PLANNING TECHNICAL REVIEW COMMITTEE –AGENDA

TECHNICAL REVIEW COMMITTEE MINUTES – WAIV-2023-0004

Application Type: Site Review
Applicant(s): Kniphfer LLC
Owner(s): Kniphfer LLC
Location: 43 Back River Road (Tax Map I, Lot 55-A)
Date: June 22, 2023

A&M Project #: 3188-01
Re: TRC Response
Tax Map I, Lot 55-A
43 Back River Road

SCALE: 1/8" = 1'-0"

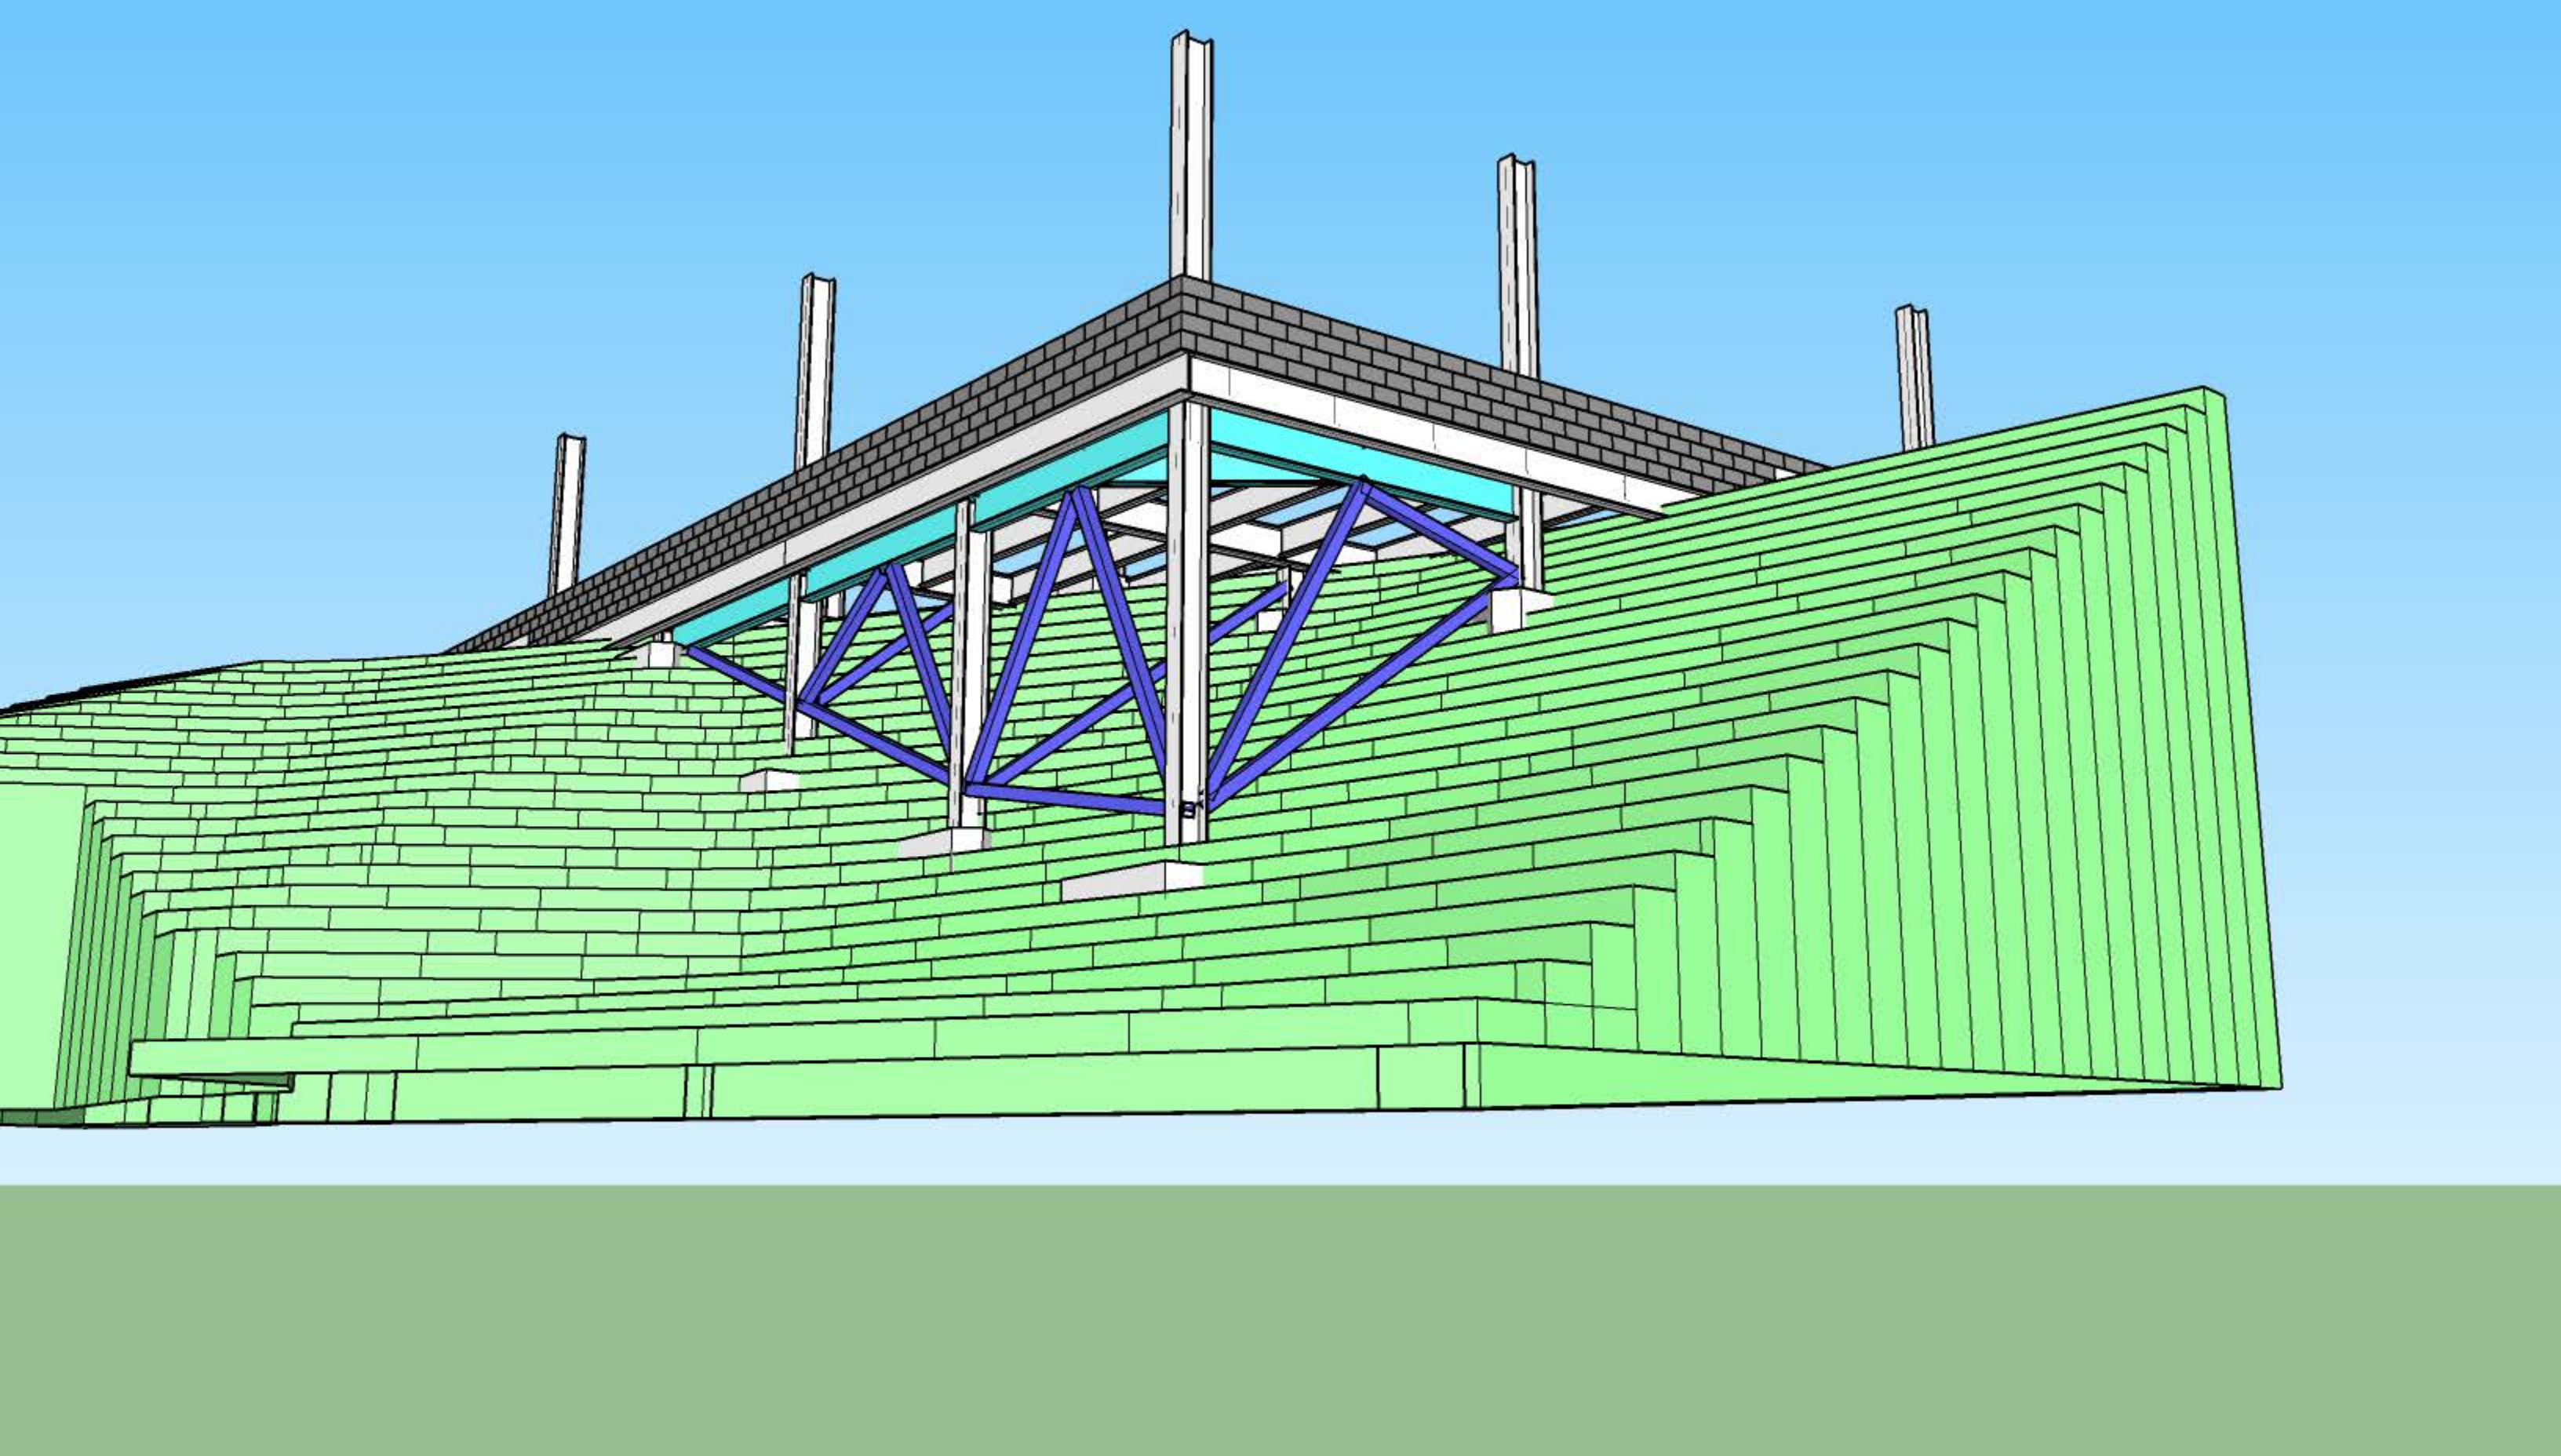
The proposal is to remove the wall from the project along with the connecting walk. The above grade deck will remain but is supported by the building and any additional peers that may be needed per the structural plan. Enclosed is a rear elevation of the revised building and a wireframe view of the structure adjacent to the slope. Based on the peer design there is no need for the wall to be installed.

Working with the project Geotechnical Engineer, Harry Wetherbee, PE, it was determined that the slope can be reinforced with a rip-rap lining. This lining will allow the slope to remain stable and allow the small amount of roof to discharge without causing erosion over time. The majority of the roof is designed to be flat and internally draining, with small mansard roofs proposed along the perimeter.

Figure 2 - Future Right-Turn Bay Analysis

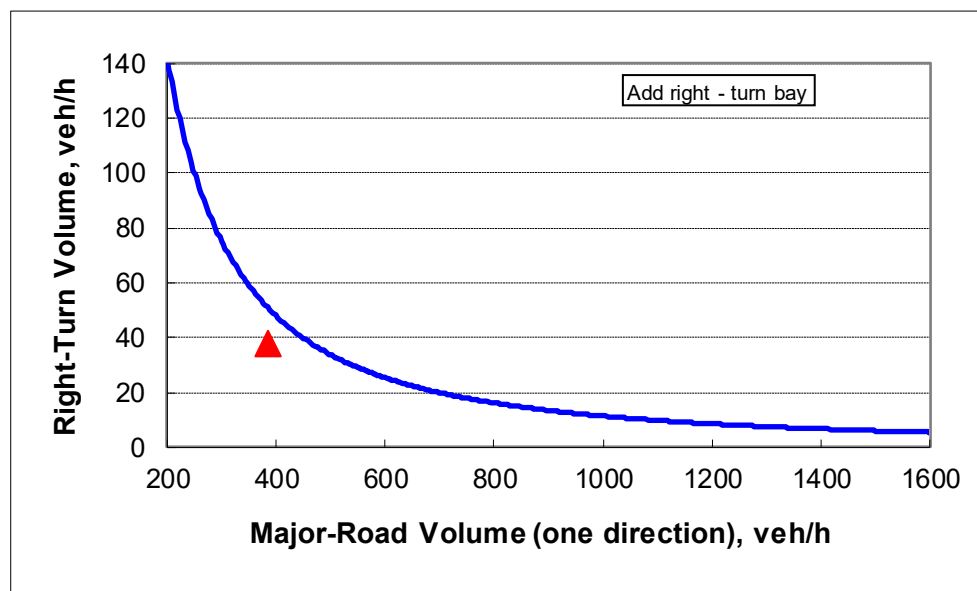
- *Consider a turning lane on Back River Road due to shortened queue on Back River Road by second curb cut or provide committee with supporting information to omit said lane.*

A&M Response: The data provided illustrates that a turning lane is not warranted due to the number of trips anticipated at the facility. Additionally, the proposed site plan illustrates that 10 cars can be accommodated on site, which exceeds the normal drop off scenario by nearly double the number of vehicles.

In order to determine whether a right-turn bay be appropriate under current conditions, the 2006 existing peak hour traffic on Back River Road was projected to 2023 using the 1% per year background growth rate. This results in 353 vehicles in the southbound direction and 246 vehicles in the southbound direction. Additional traffic generated by the expanded childcare center was added to the right-turn movements along Back River Road.

As seen in Table 2, the proposed traffic volumes are not sufficient to recommend a right-turn bay.

DRAWING TITLE:	SHEET No.
PARKING LAYOUT PLAN	C-1

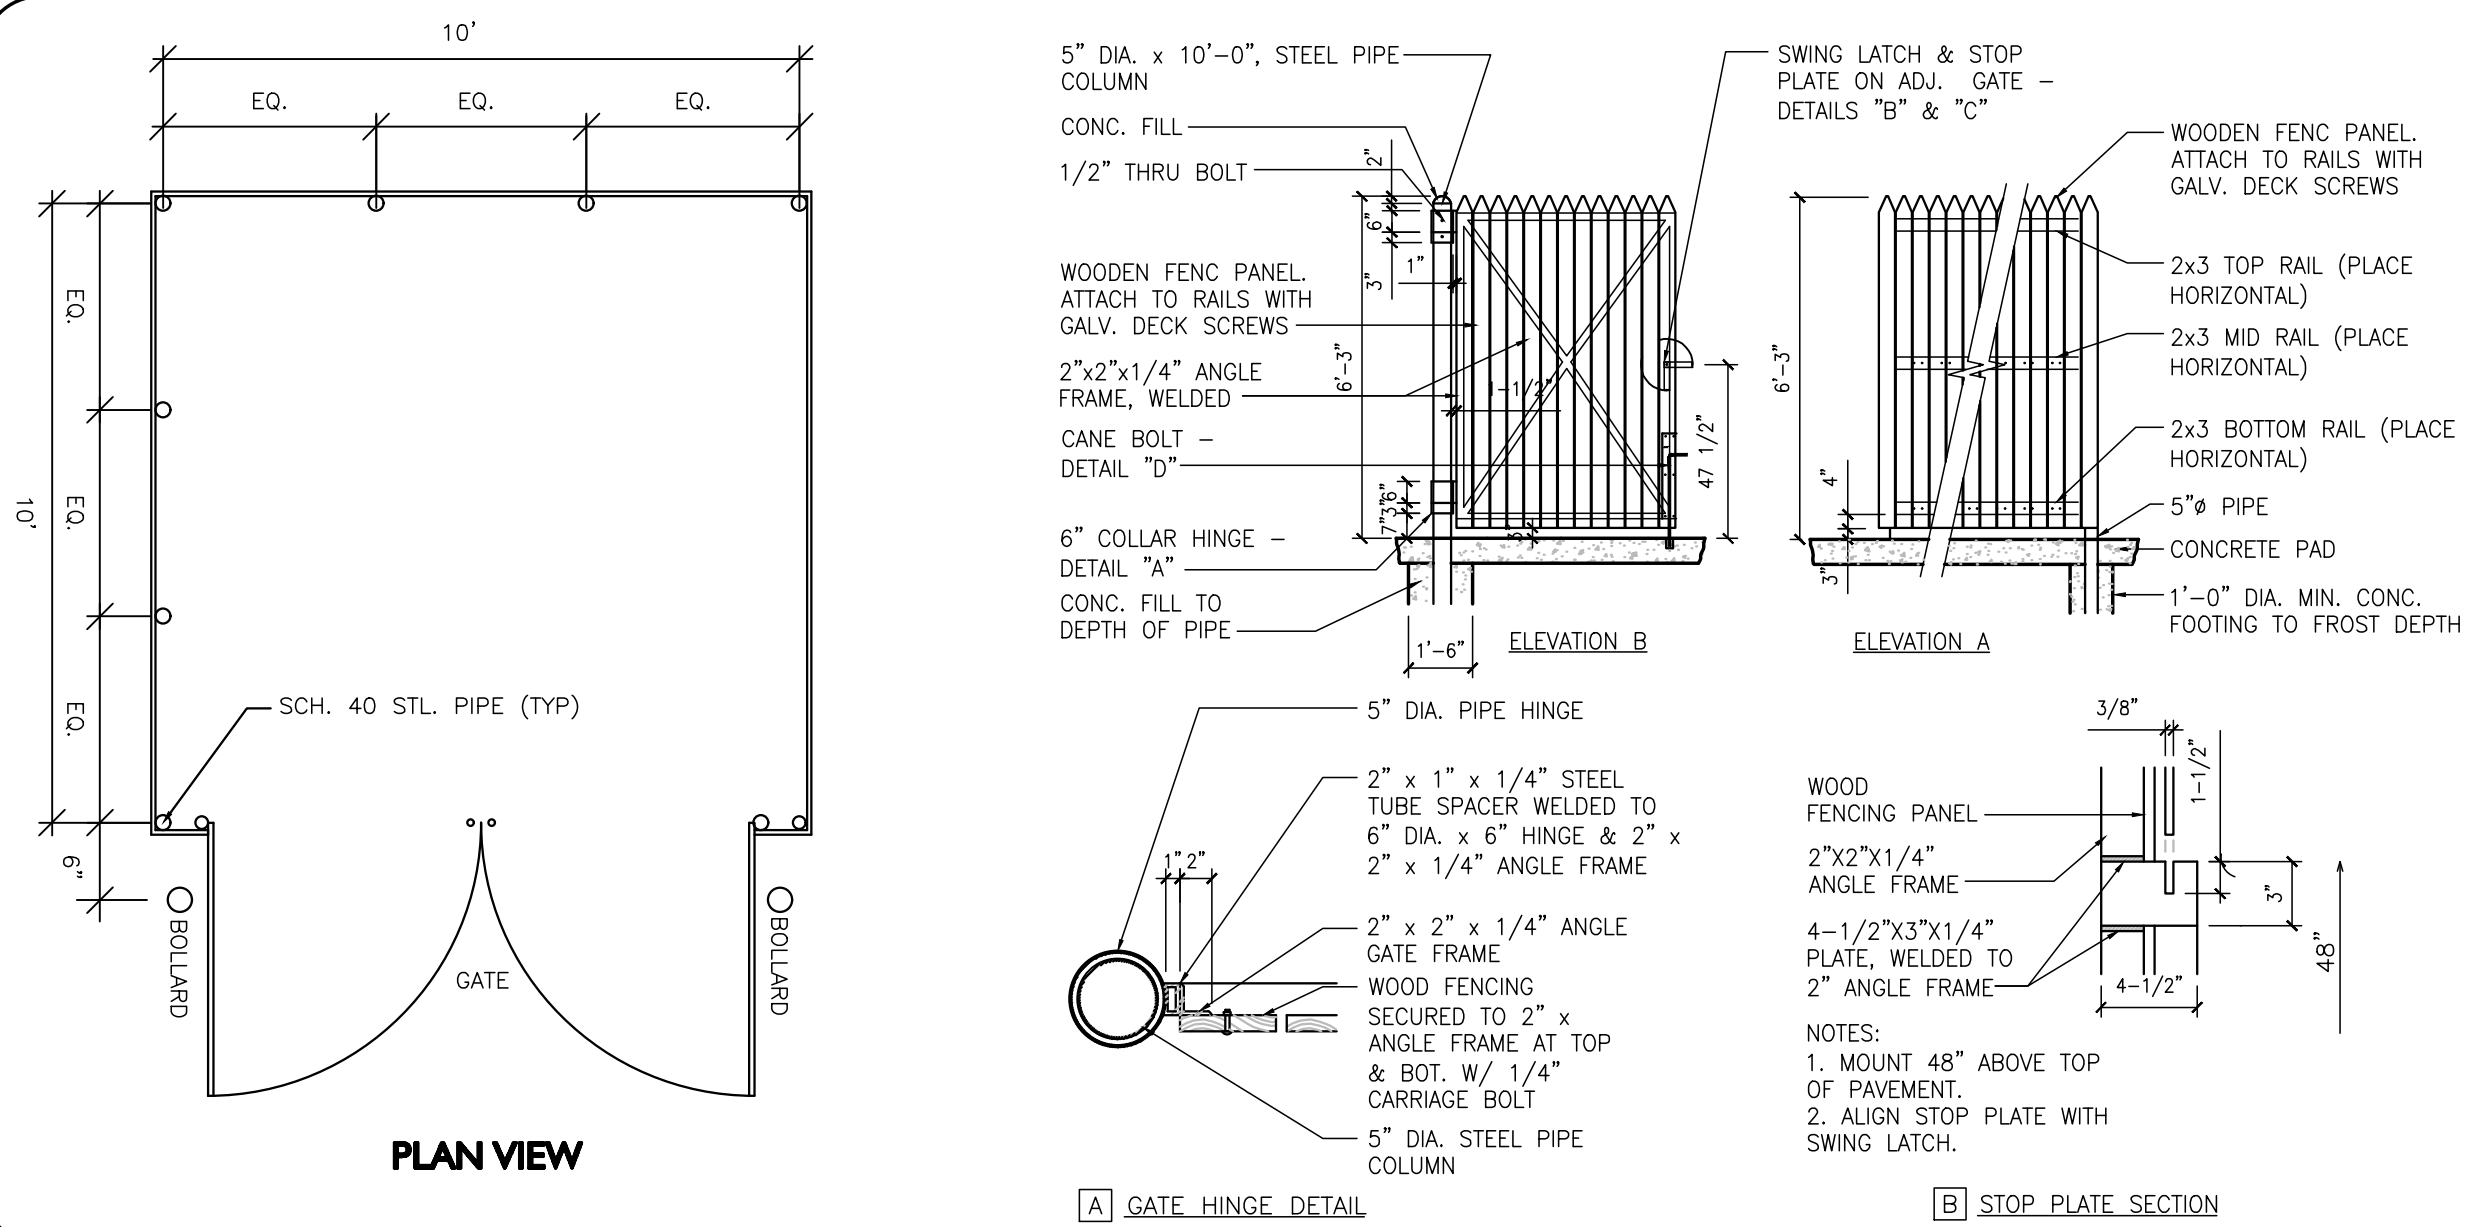
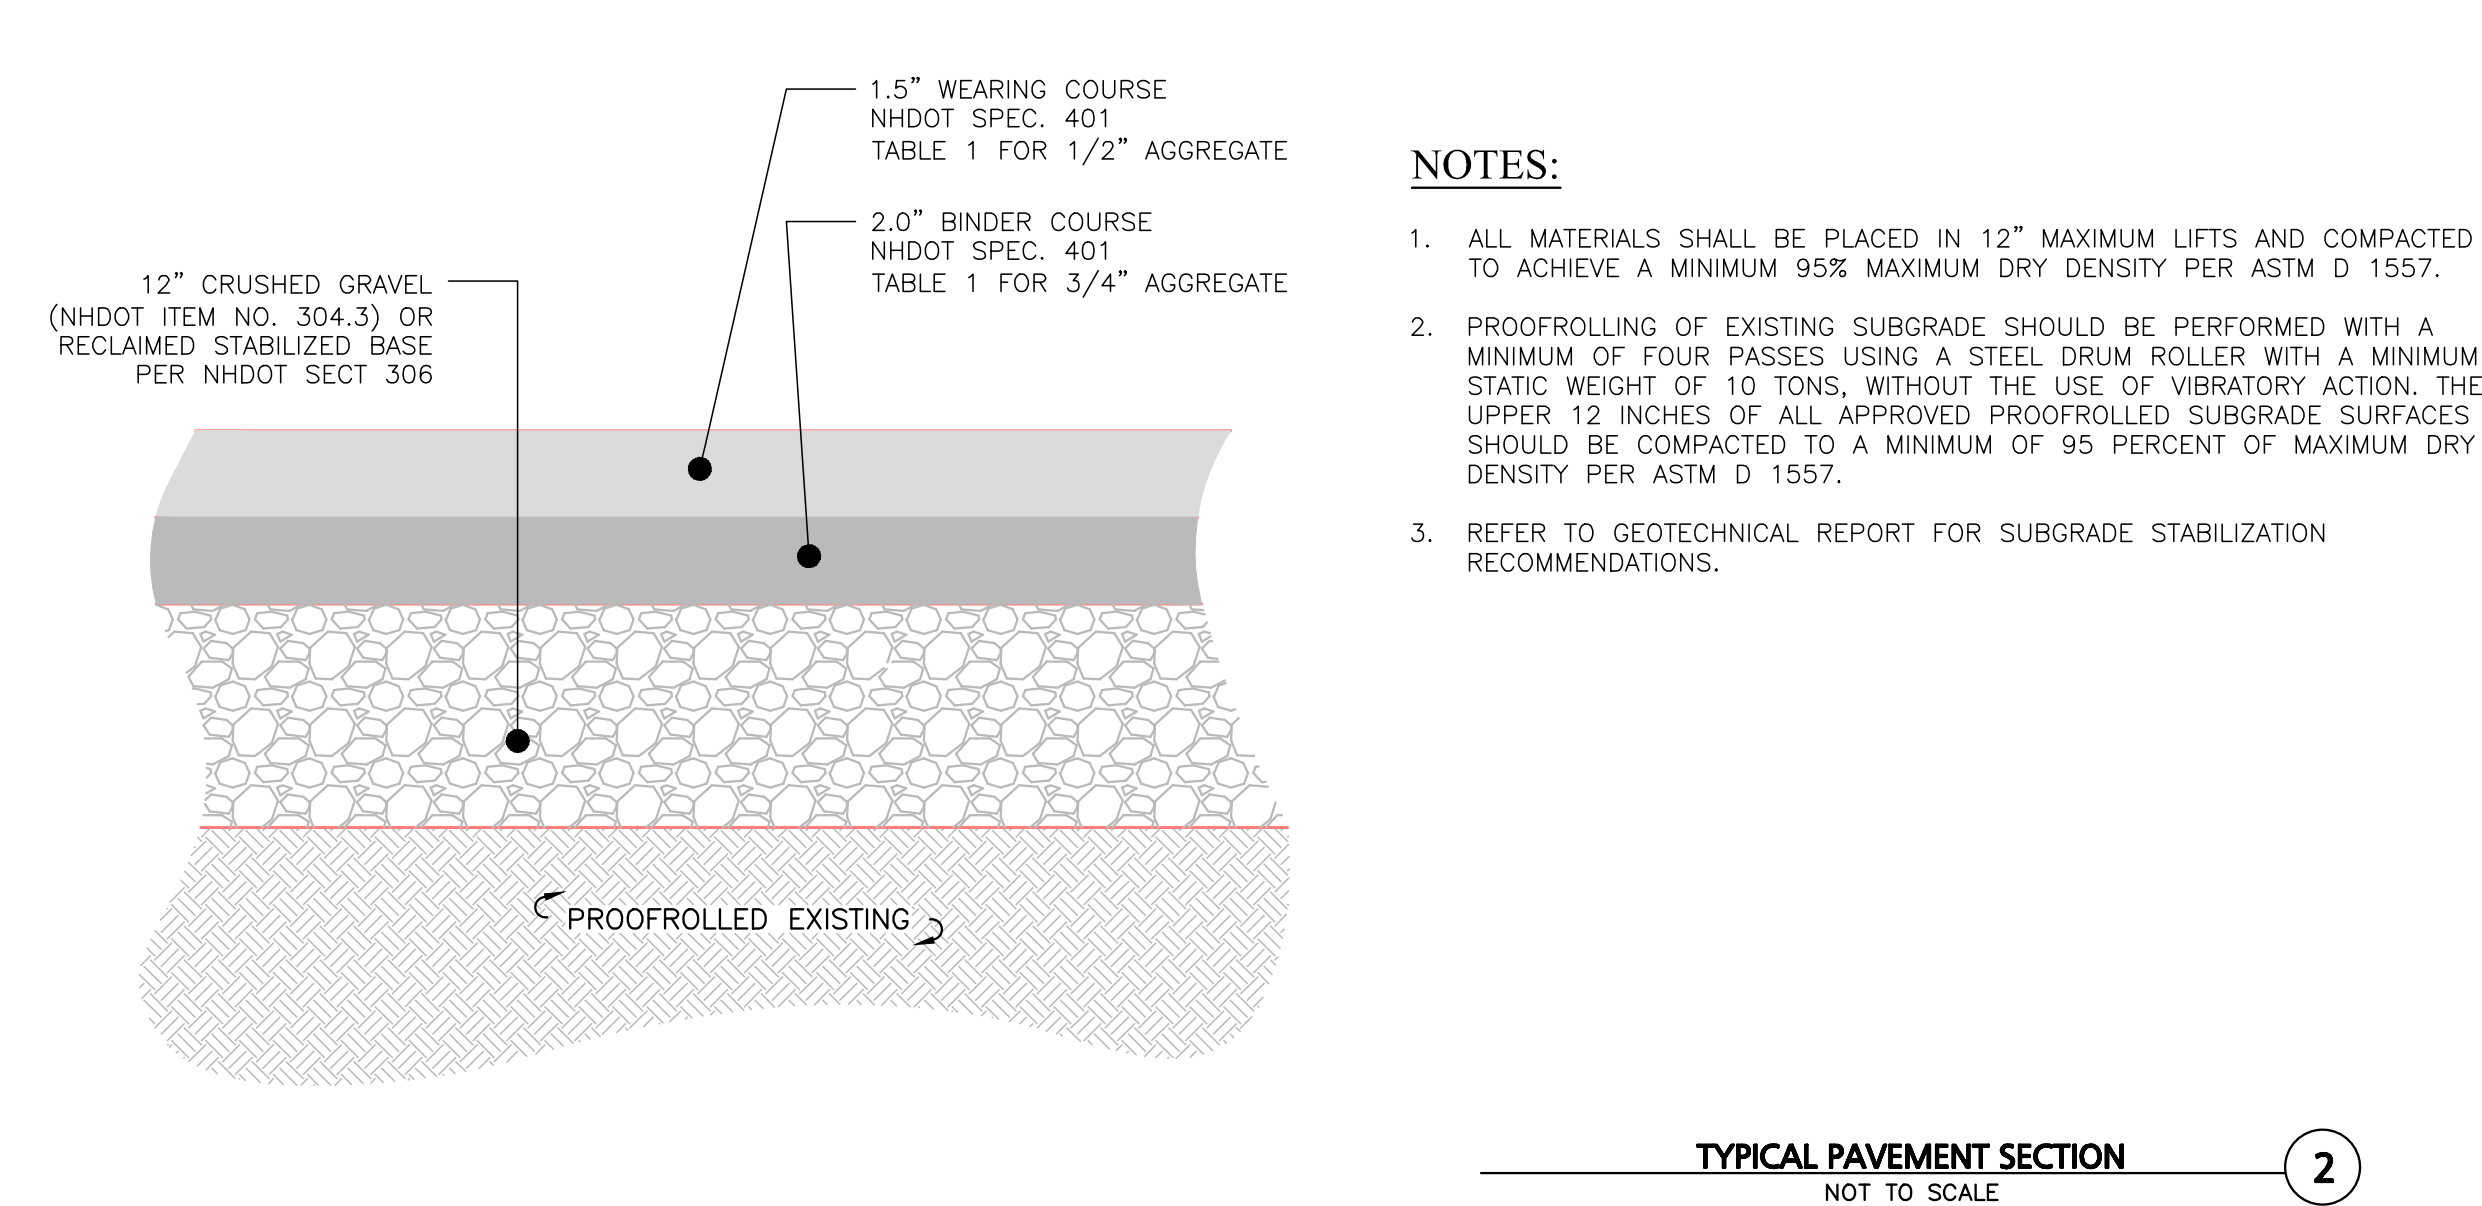
- *Sheet C-1: Parking Layout Plan shows an accessible parking detail with a V in one space. The note provided states that it denotes an accessible space. It is assumed this is meant to be van accessible.*

- *Sheet C-1: Identify the location of the van accessible space on the site plan.*

- *Sheet C-1: Identify the maximum slope on the accessible ramp for accessible parking and whether it is in the sidewalk or on the pavement. It is unclear from the notes.*

- *Sheet C-1: Wooden stairs are located at the front entrance and thus it is likely inaccessible. Identify ADA entrance.*

- *Sheet C-1: Add second Do Not Enter Sign on back side of Stop Sign at exit.*

- *Sheet C-1: Provide Do Not Enter sign under the one-way sign.*

- *Sheet C-1: Typically granite curbing is required within the right of way. However, the existing roadway has bituminous curbing and we would support a waiver to provide bituminous curbing.*

- *Sheet C-1: 16 spaces are provided. Applicant should comment on whether parking is sufficient for the use and where additional parking could be added if deemed necessary. Engineering would support showing "paper spaces" for future construction.*

- *Sheet C-1: Identify location for snow storage.*

- *C-1 Note 17 – Remove note.*

A&M Response: The updated plans better illustrate the location of the van accessible space.

A&M Response: The updated plans better illustrate the location of the van accessible space.

A&M Response: The slope has been better illustrated on the updated plans.

A&M Response: The accessible route has been illustrated on the updated plans.

A&M Response: A second Do Not Enter sign has been added to the plans.

A&M Response: A Do Not Enter sign has been added to the plans at the location indicated.

A&M Response: A formal waiver has been provided for the use of bituminous curbing to match the existing.

A&M Response: The parking shown on the plans is sufficient for the daily operations of the expanded existing daycare facility. The plans have also been updated to illustrate a location for future parking in needed to support the daycare operations.

A&M Response: Snow storage has been shown on the plans.

A&M Response: Note has been removed from the updated plans.
